ANGEL PLACE
LEVEL 8, 123 PITT STREET
SYDNEY NSW 2000

26 April 2019

CHATSWOOD CHASE DA 2017/503 - SNPP REQUEST FOR INFORMATION

APPENDIX A – AMENDED DESIGN REPORT & PLANS

Drawing Title
Victoria Ave Awning Extent

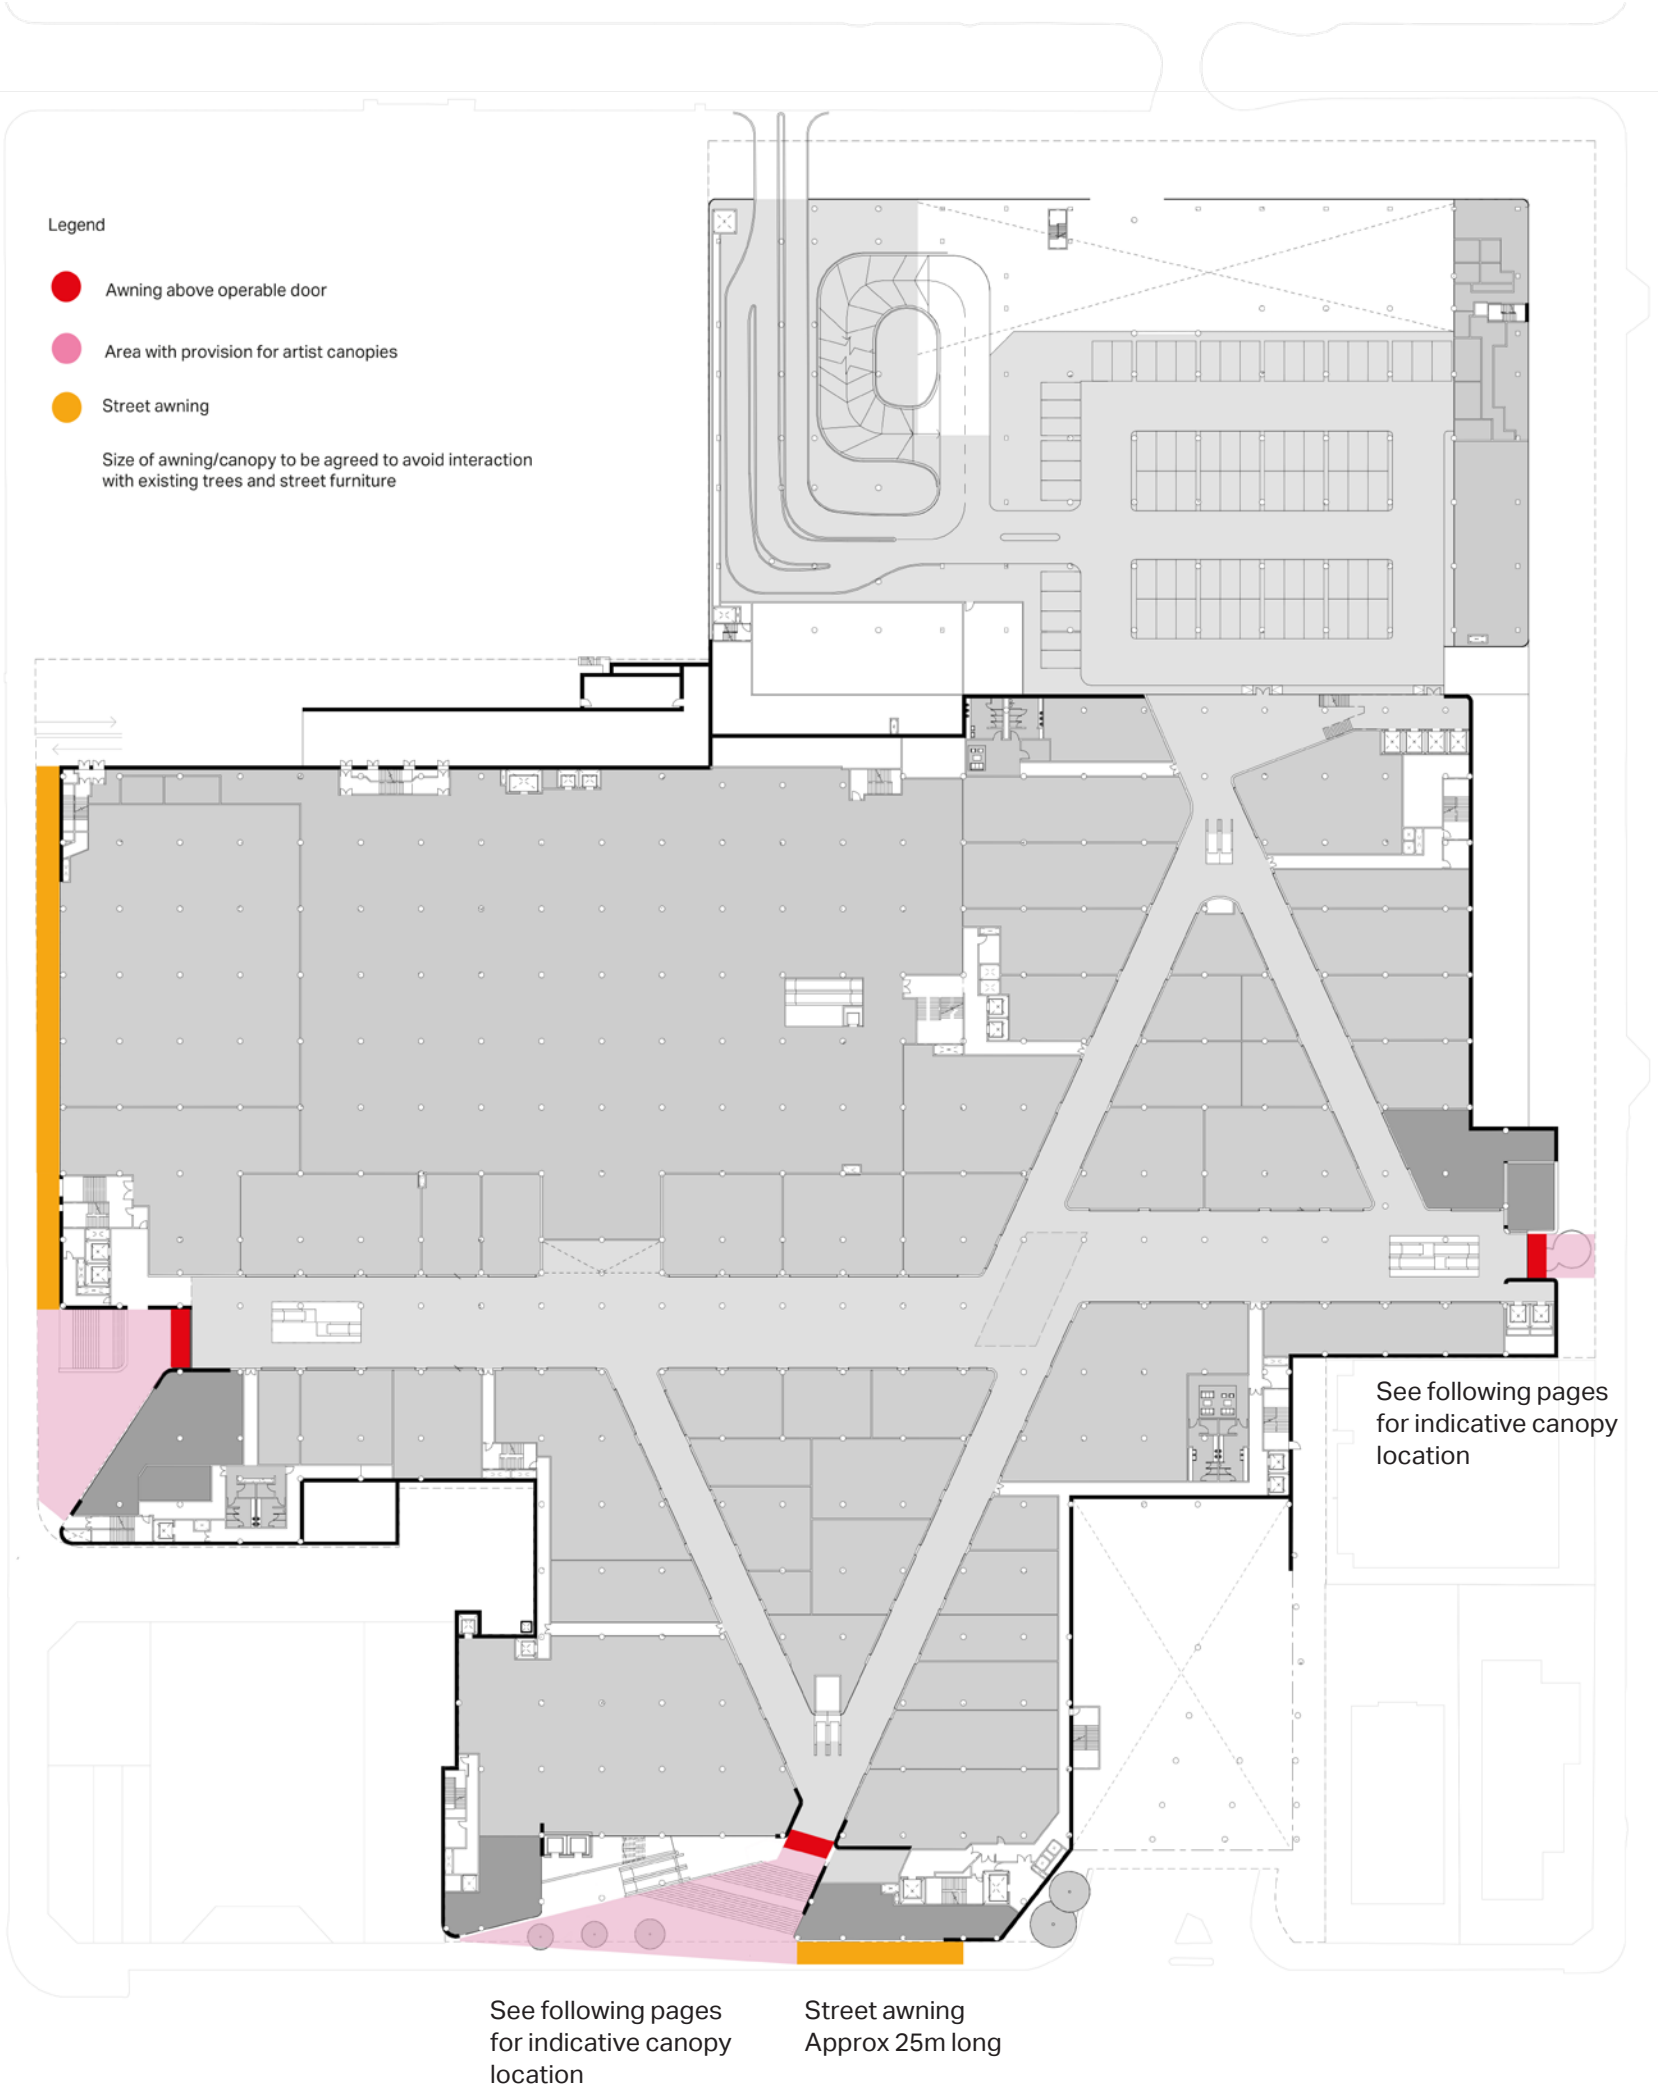
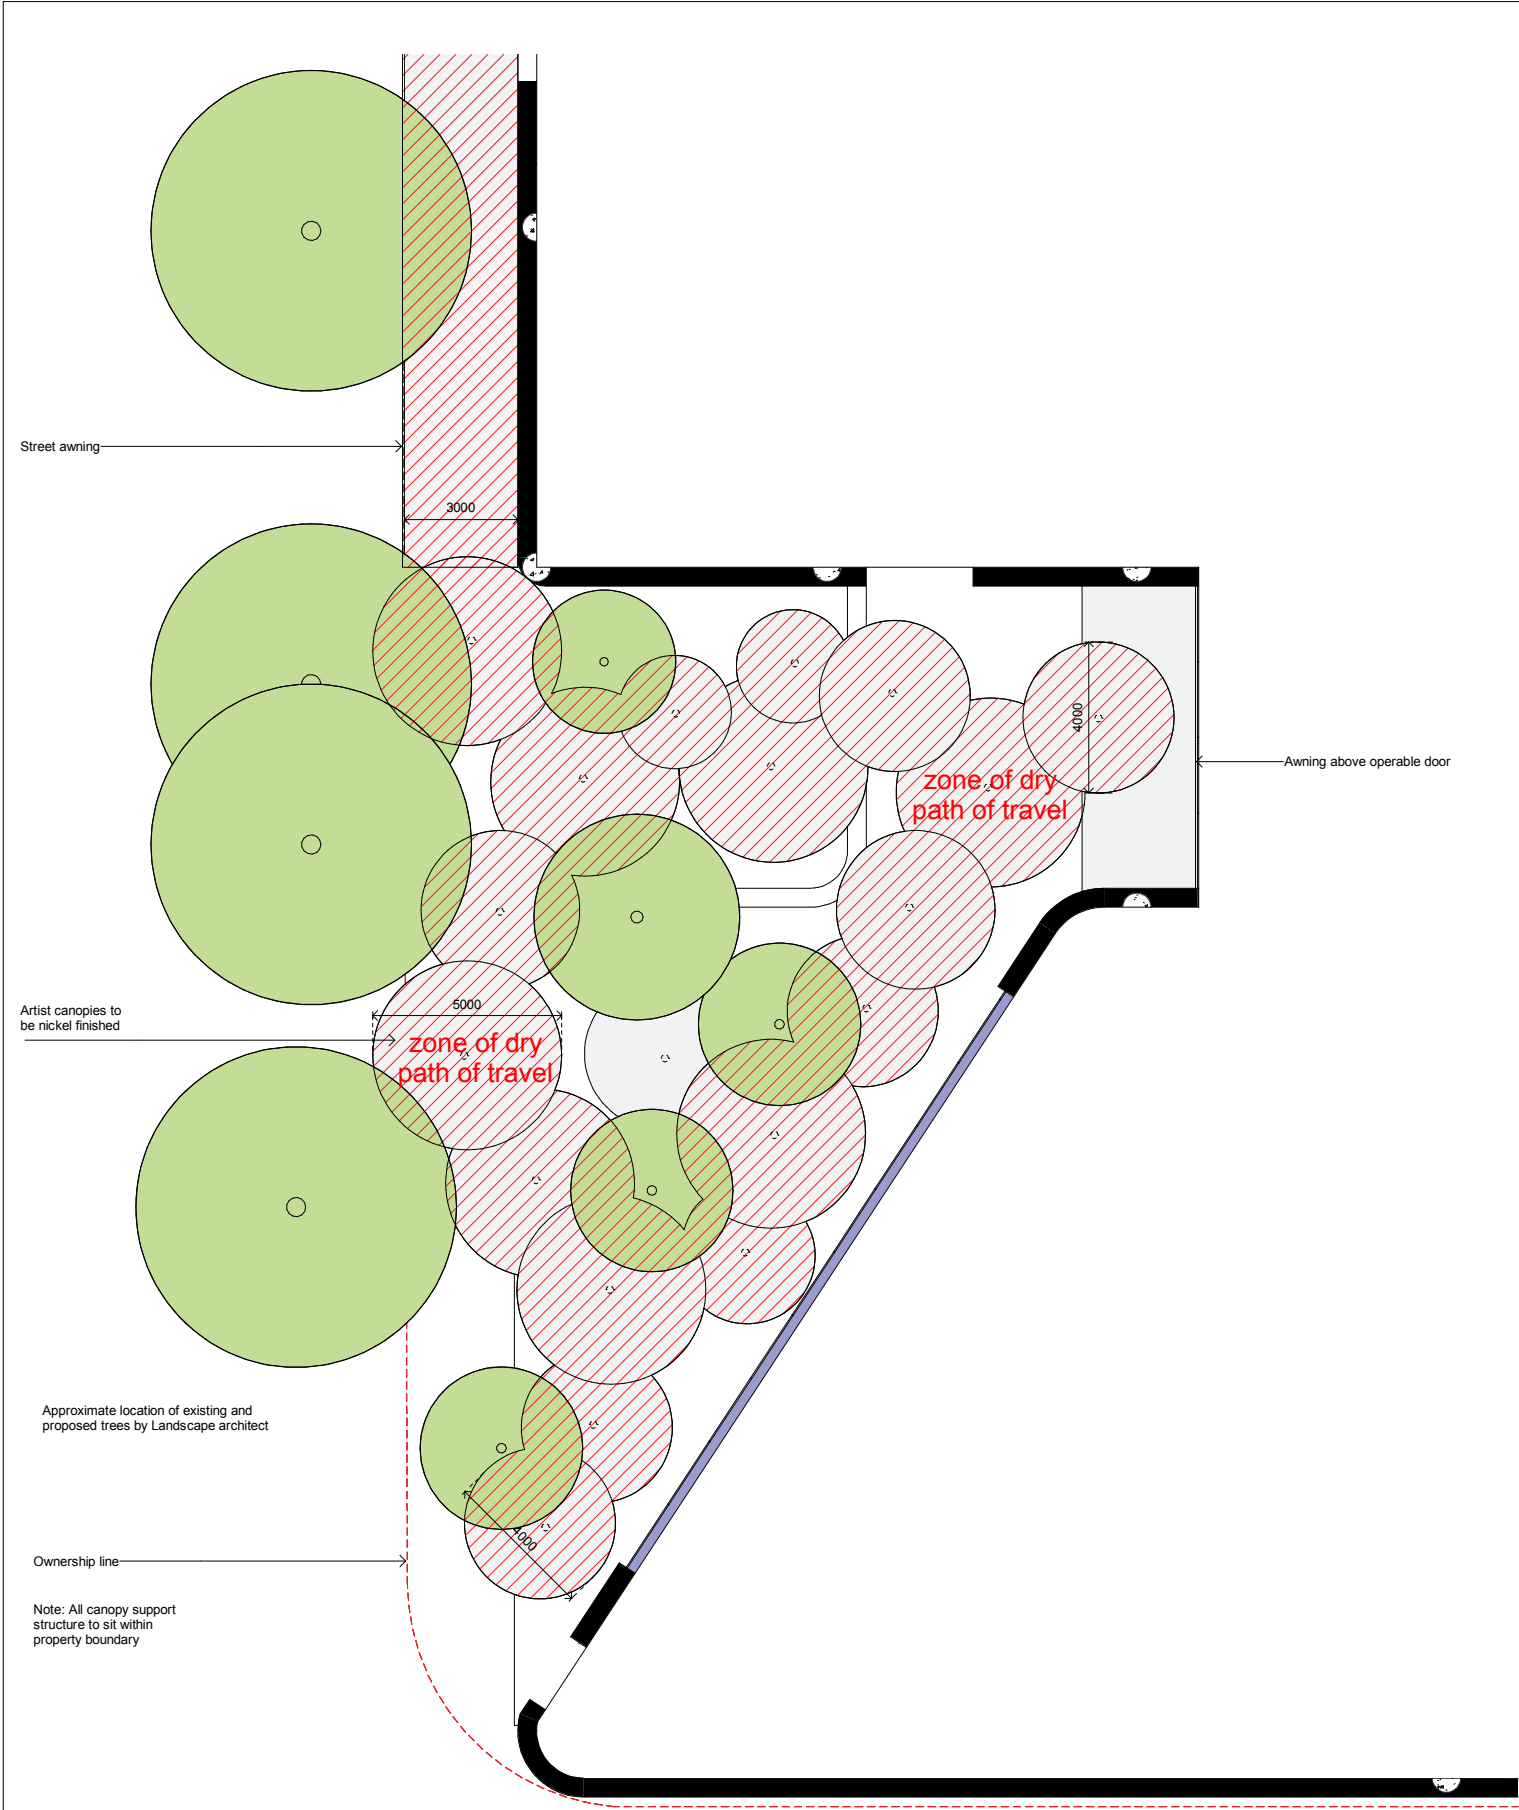
- Updated awning details which demonstrate increased continuity and coverage to enhance pedestrian amenity around key frontages and entrances to the shopping centre.
